**Re: Southern California Edison's Comments to the Draft Environmental Impact Report for the Alberhill System Project and Valley-Ivyglen Subtransmission Line Project**

### DRAFT ENVIRONMENTAL IMPACT REPORT ~ SCE COMMENTS

Attachment A - Illustration of the Proposed and Alternative DD Substation Sites and the Corresponding 115 kV lines

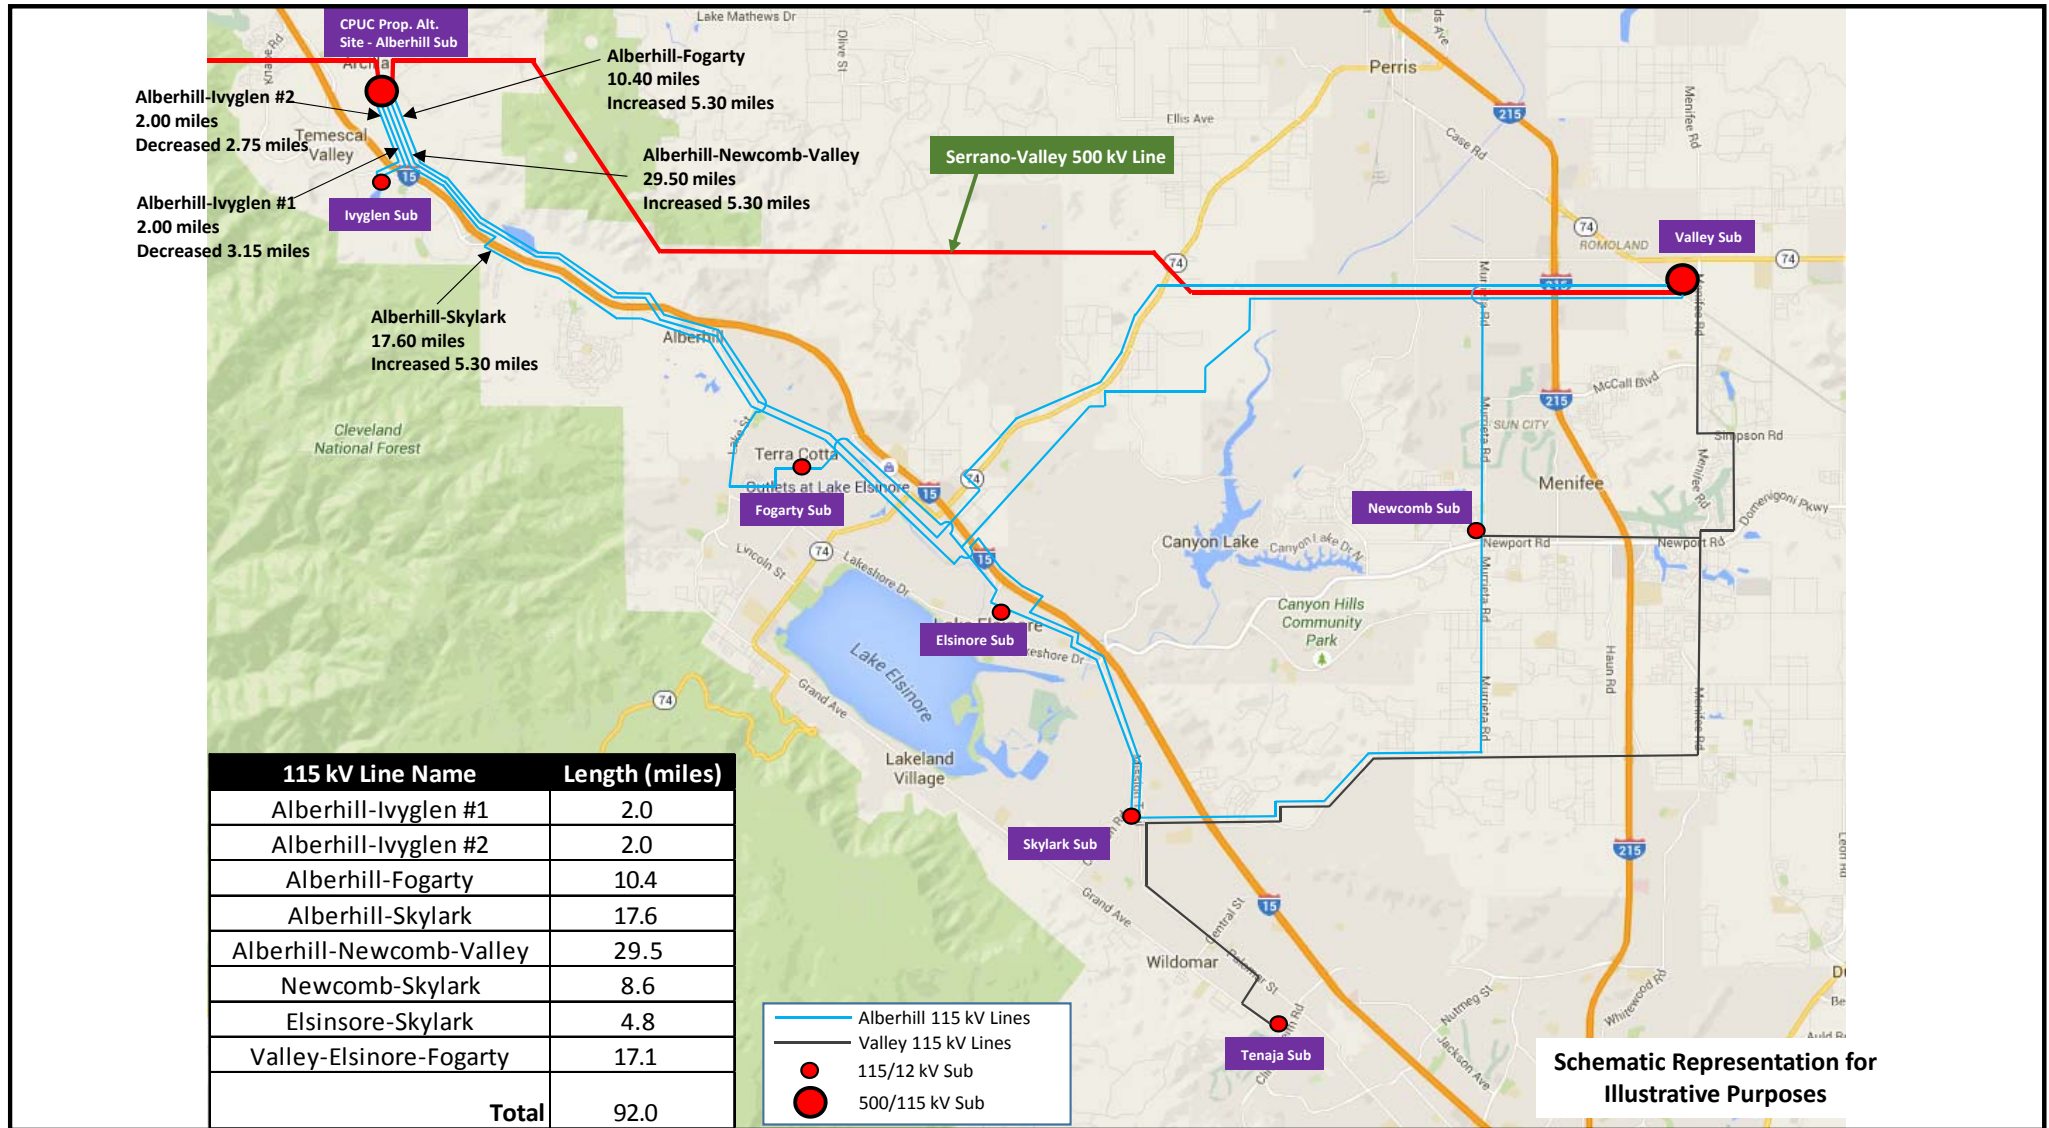
Alternative DD is beset by a variety of technical, environmental, legal and economic challenges and doesn’t meet the project objectives, which render it infeasible as defined by CEQA. Alternative DD would include construction of a 500 kV substation on the Serrano Commerce site, which is located approximately five miles north of SCE’s proposed Alberhill Project substation site. The 500 kV transmission lines would exit directly north from the substation and tie into the existing Serrano-Valley 500 kV transmission line. Similar to the proposed Alberhill Project, up to five 500 kV transmission lines and ten 115 kV subtransmission lines may need to connect to the substation at

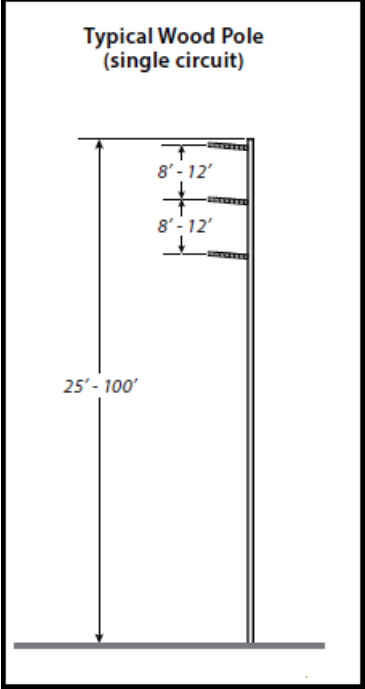
Project	Section	Page	DEIR Language	SCE Recommended Language
Alberhill/ Valley- Ivyglen	2.3.1	2-18	<p>Figure 2-4 states:</p> <p>“Lightweight Steel Pole (single circuit)”</p> 	<p>SCE suggests the following edits:</p> <p>“Lightweight Steel Pole (<del>single</del><u>double</u> circuit)”</p>
Alberhill/ Valley- Ivyglen	2.3.1	2-18	<p>Figure 2-4 states:</p> <p>“Typical wood pole (single circuit) 25' - 100' “</p>	<p>SCE suggests the following edits:</p> <p>“Typical wood pole (single circuit) <del>25</del><u>75</u>' – 100’</p> <p>Please add the following dimensions to the Span Guy in Figure 2-4:</p>

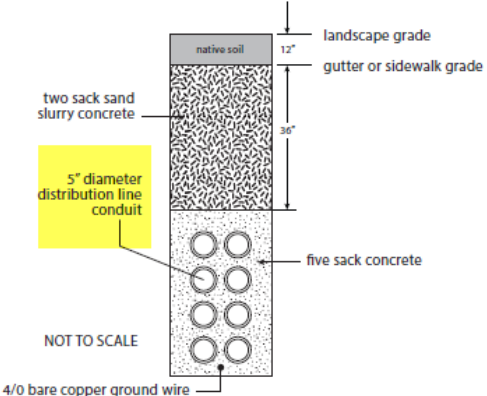
Project	Section	Page	DEIR Language	SCE Recommended Language
			 <p>The diagram shows a vertical wood pole with a total height dimensioned as 25'-100'. Two horizontal sections are shown near the top, each dimensioned as 8'-12'.</p>	<p>Guy stub poles are typically 35' – 50'</p>
Alberhill/ Valley- Ivyglen	2.3.1.1	2-18	<p>Figure 2-4, Subtransmission Structures and Underground Conduit - Distribution Underground Duct Bank Configuration figure states:</p> <p>“Typical Underground Duct Bank Configuration for Underground Distribution Line Installations”</p> <p>5” diameter distribution line conduit</p>	<p>Please relabel figure to read:</p> <p>“Typical <del>Underground</del> Duct Bank Configuration for Underground <del>Distribution</del> <u>Sub-transmission</u> Line Installations”</p> <p>5” diameter <del>distribution line</del> conduit</p>
